Agency Correspondence

RE: Requesting Comments on an up to 200-megawatt Wind Farm in Bowman County, North Dakota

Figure 1
Preliminary Project Area
Bowman Wind Project
Bowman County, North Dakota

Figure 1 - Turbine locations associated with FIDs 3, 11, 16, 37, and 77

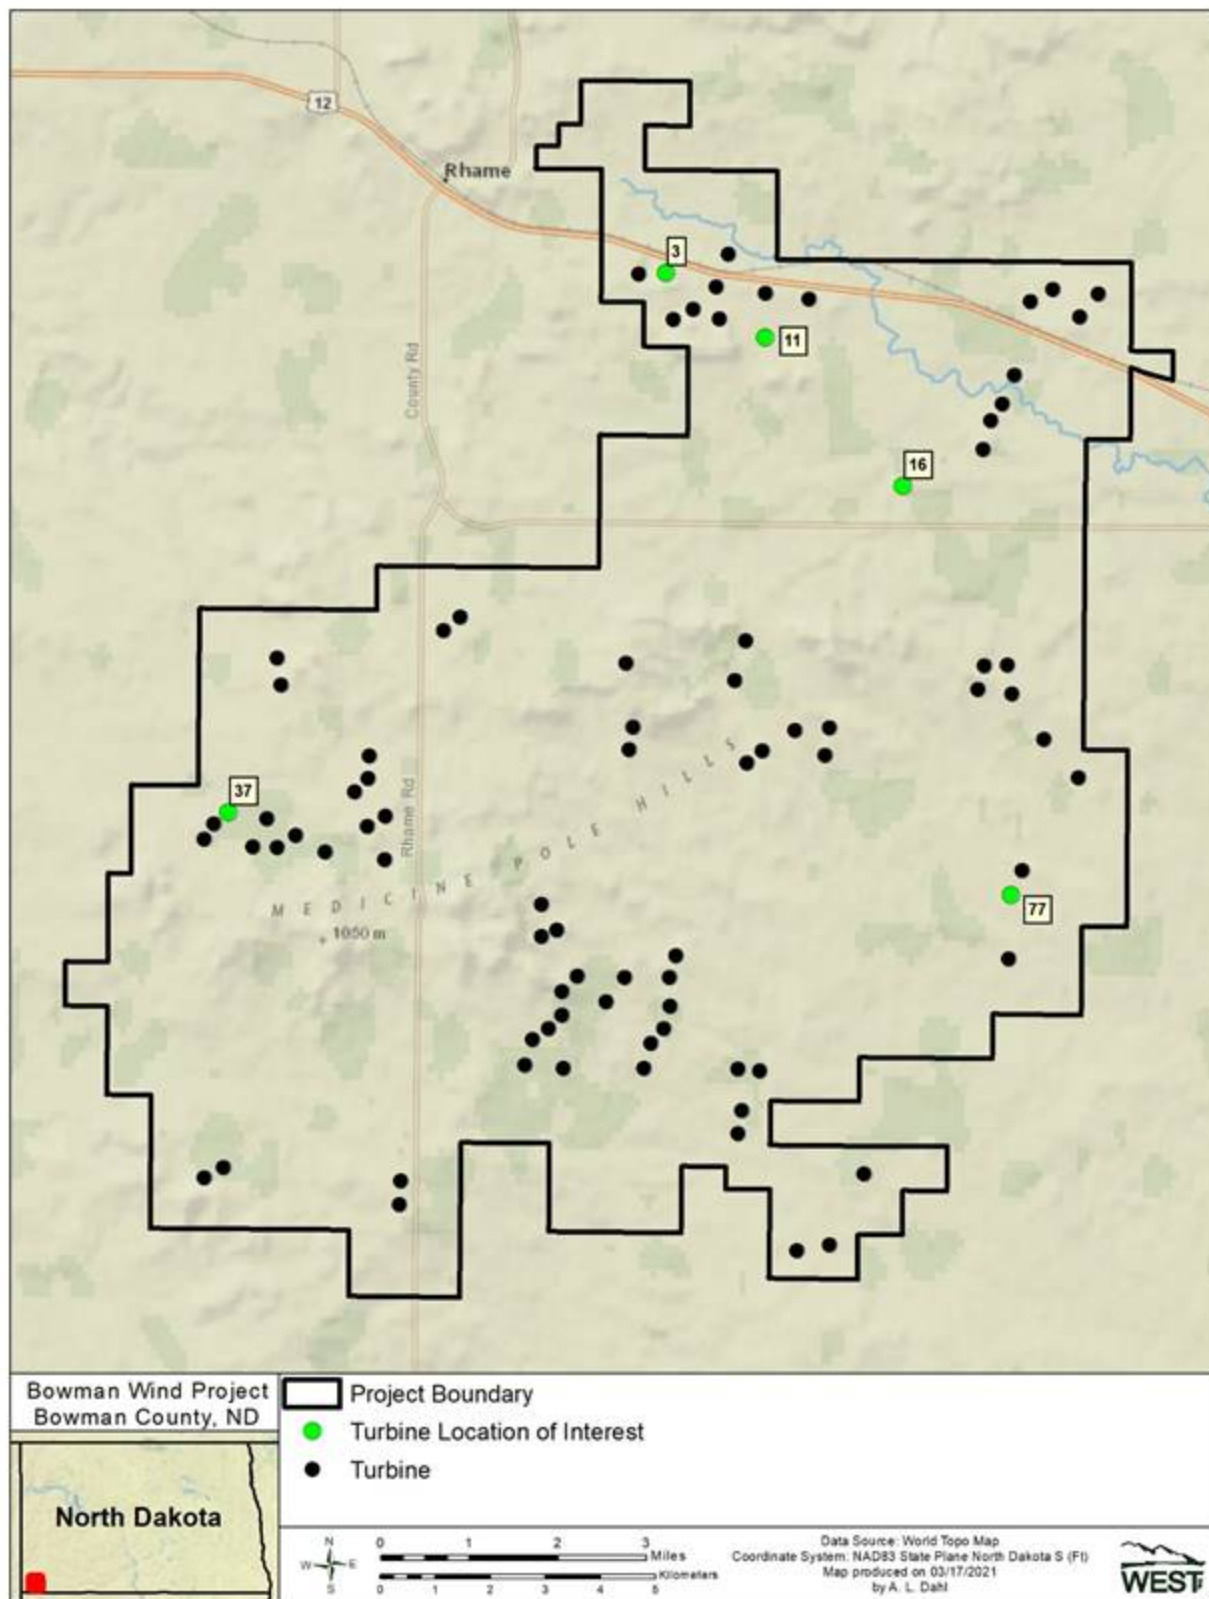
Based on the native prairie/grassland assessment, turbines with FIDs 3, 11, 16, 37, and 77 (Figure 1) were located in areas identified as previously broken grasslands for the following reasons:

- Grasslands within the Assessment Area of turbines FID 3, 11, and 37 were identified as broken based on the NDGF Native layer, historic aerial imagery (1957-1962) that showed evidence of tillage, and results of the field assessment which indicated the presence of rock piles, vegetation in straight lines, and dominance of non-native planted species (i.e., smooth brome grass and alfalfa), which all indicate previous tillage.

- Grassland within the Assessment Area of turbine FID 16 were identified as broken based on not occurring within the NDGF Native layer, recent aerial imagery that indicated disturbance and degradation in 2019 and 2020, landowner confirmation, and results of the field assessment which indicated the presence of rock piles, vegetation in straight lines, and dominance of non-native planted species (i.e., smooth brome and *Poa* spp. grasses), which all indicate past tillage.

- Grassland within the Assessment Area of the turbine FID 77 was identified as broken based on not occurring within the NDGF Native layer and historic aerial imagery that showed evidence of tillage (1957 -1962).

North Dakota Natural Heritage Inventory
Rare Animal and Plant Species and Significant Ecological Communities

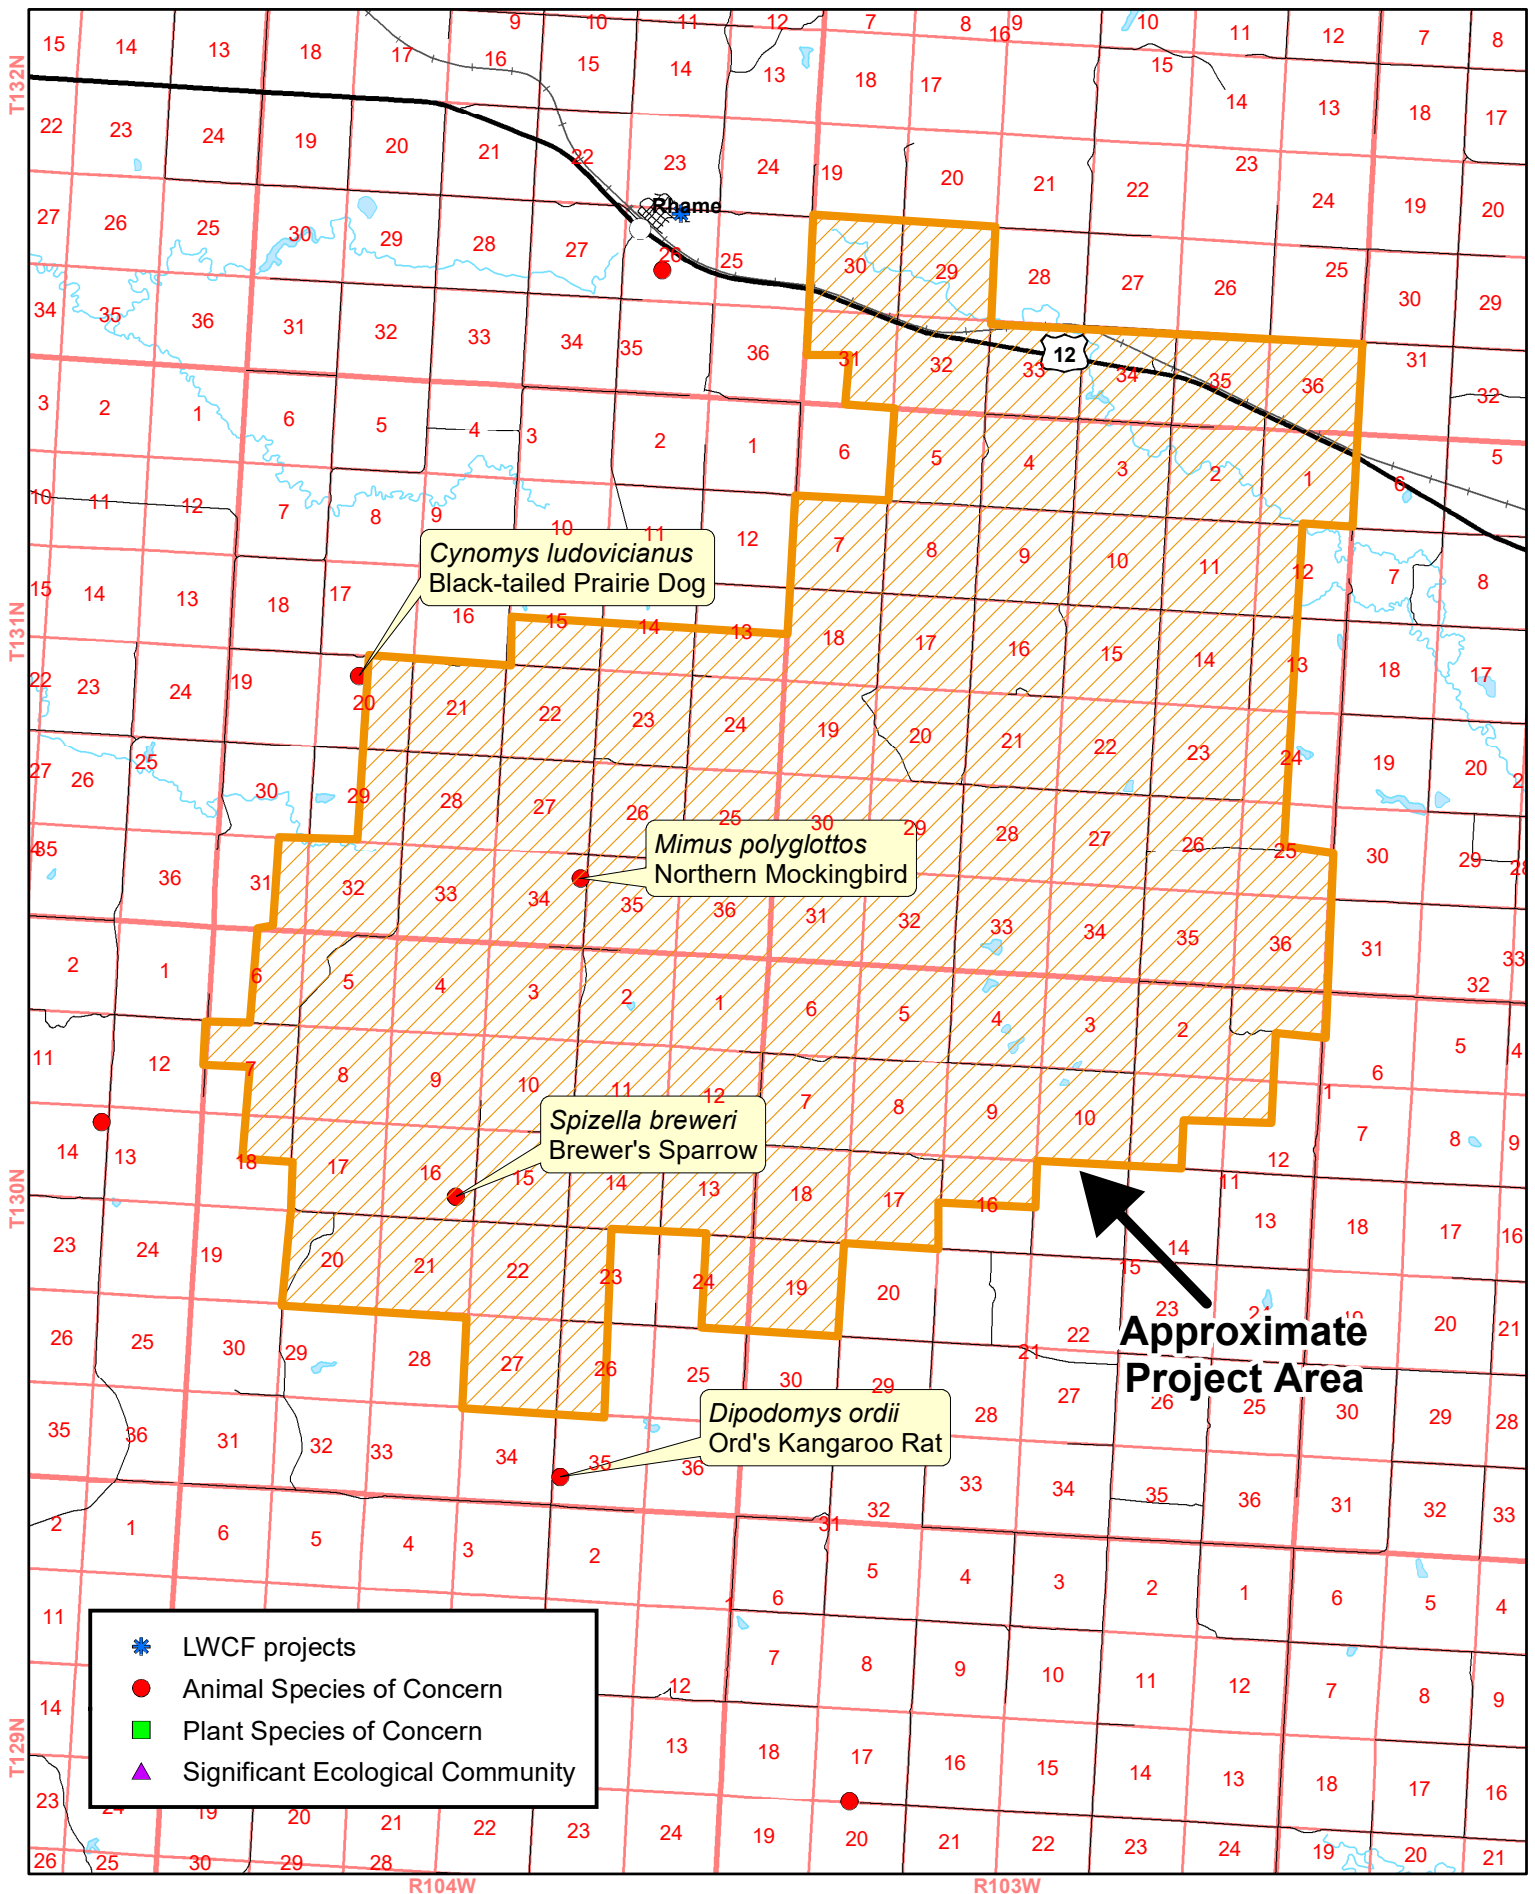
The North Dakota Natural Heritage biological conservation database has reviewed the project to determine if any current or historical plant or animal species of concern or other significant ecological communities are known to occur within an approximate one-mile radius of the project area. Based on this review, we have several species of concern documented within or adjacent to project site. The absence of data may indicate that the project area has not been surveyed, rather than confirm that the area lacks natural heritage resources. A map and spreadsheet with natural heritage data has been attached.
